CITY PLANNING COMMISSION

APPLICATION: Special Permit to allow a 24 hour convenience store within 500 feet of residentially zoned property.

LOCATION: 8461 Folsom Boulevard; Northeast corner Folsom Boulevard and Julliard Drive

PROPOSAL: The applicant is requesting the necessary entitlements to establish a 24 hour a.m. and p.m. mini-market and gas station from an existing gas station

MONUMENT SIGN IN LIEU OF POLE SIGN

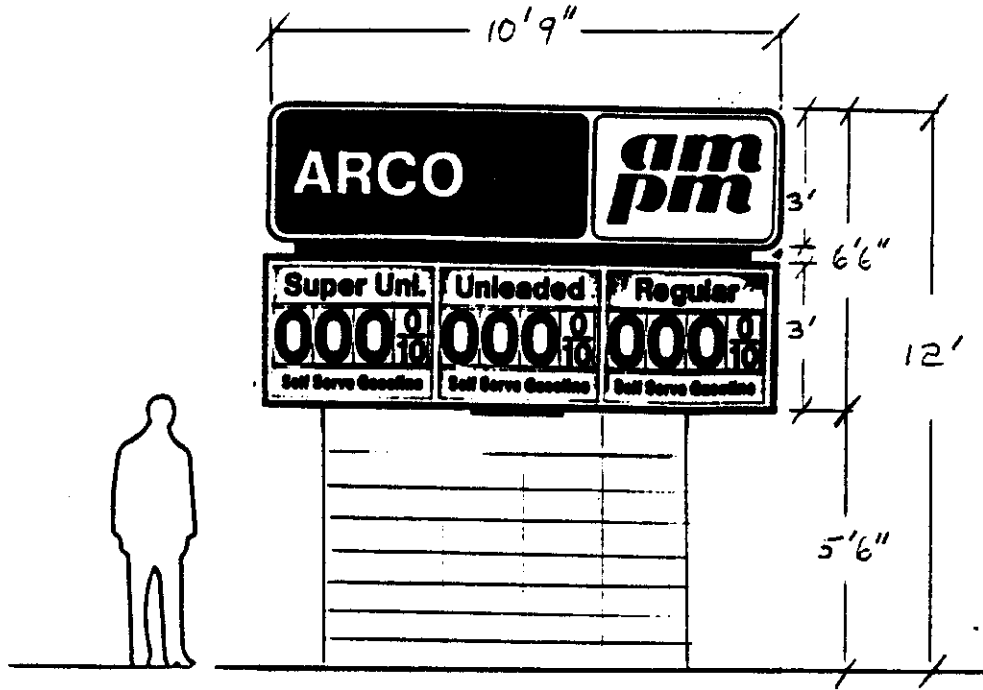
5. A sign program shall be reviewed and approved by the Planning Director prior to issuance of sign permits. To reduce visual sign clutter on a major intersection, staff suggests that the proposed double pole sign on the corner be limited to 12 feet in height and redesigned as a monument sign with a masonry base. (Refer to Exhibit F for staff recommendation used in a recently approved project in the City for ARCO).

2. The applicant shall obtain a revocable encroachment permit from the City for any of the planter areas which may be located in the City right-of-way prior to the issuance of building permits.
3. The applicant shall obtain the necessary permits from the Building Division to demolish the existing service station and remove existing gasoline tanks.
4. The applicant shall submit detailed landscape and irrigation plans for review and approval by the Planning Director prior to building permit issuance. The parking area should meet the minimum 50 percent shading requirement if possible.
5. Applicant shall submit detailed signage program for review and approval by the Planning Director prior to issuance of sign permits. The proposed corner pole sign shall be redesigned as a monument sign with a masonry base and shall not exceed 12 feet in height, as per Exhibit F.
